PLANNING AND REDEVELOPMENT DEPARTMENT STAFF REPORT PLANNING COMMISSION MEETING December 14, 2006

ITEM VI-B: DESIGN REVIEW PERMIT - 3990 FOOTHILLS BOULEVARD (ELK HILLS PLAZA, BLDG. 3, PARCEL 4) - FILE #: DRP 04-61

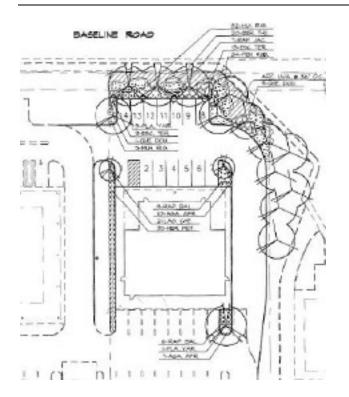
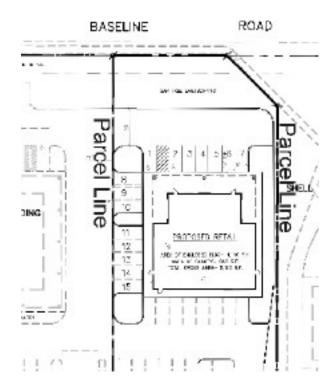
Staff is recommending approval of the proposed retail building, but with the site design revised as indicated on the right side of the following page (Attachment 5). The building size and configuration is retained, but is shifted east to remove the fourth drive aisle, creating:

- On-site landscape planters that are not dependent on agreements with the adjacent property owners and is responsive to the adjacent property owner's concerns (see discussion following on page 5);
- Opportunities for parking on the west side of the building, allowing removal of parking fronting Baseline Road; and
- With removal of parking fronting Baseline this allows expansion of the planter adjacent to Baseline Road (to approximately 38 ft.) to accommodate additional on-site oak tree plantings.

The modified site plan would remove the shared landscape planter, and in its place create three (3) parking lot planters, and seven to eight (7 - 8) parking spaces that would all be entirely within the parcel owned by Mr. Staveris (total of 14 – 15 parking spaces).

- a. The 4,150 square feet retail building shall be repositioned on the site as shown in Attachment 5, such that seven to eight parking stalls shall be installed along the western side of the building.
